DART SERVICE INSTRUCTION

TO AMEND INSTALLATION INSTRUCTIONS II135-21 REV. J
AND INSTRUCTIONS FOR CONTINUED AIRWORTHINESS ICA135-21 REV. F
OR LATER APPROVED REVISIONS

Α	NEW ISS	SUE		SAD	22	.12.09	
REV.			DESCRIPTION	BY	D	ATE	
DESIGN		SAD	DART AEROSPACE LTD				
DRAWN		SAD	HAWKESBURY, ONTARIO, CANADA				
CHECKED		MB	DRAWING NO.	REV. A			
MFG. APPR.		N/A	DSI 9899		SHEET 1 OF 2		
APPRO	VED	SAD ,	TITLE			SCALE	
DE APPR. DS		DS 🕌	REPLACEMENT FAST	ENE	RS	NTS	
DATE 22.12.09			COPYRIGHT © 2022 BY DART AEROSPACE LTD. THIS DOCUMENT IS PRIVATE AND CONFIDENTIAL AND IS SUPPLIED ON THE EXPRESS CONDITION THAT IT IS NOT TO BE USED FOR ANY PURPOSE OR COPIED OR COMMUNICATED TO ANY OTHER PERSON WITHOUT

FIGURE 1: UPDATED FASTENER ARRANGEMENT

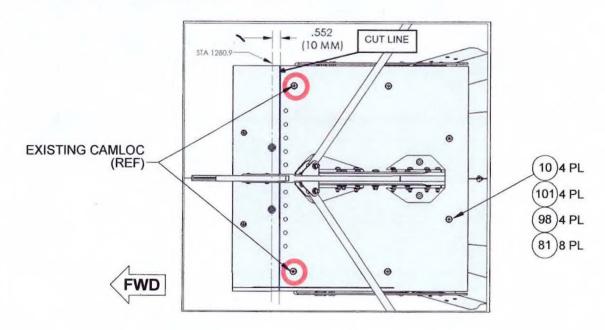
If OEM Camlocs are installed in the 2 fwd locations as shown in Figure 1 of this DSI, then it is acceptable to re-install the nosecover panel on the aircraft using the 2 existing Camlocs in lieu of MS27039-1-10 screws at those locations.
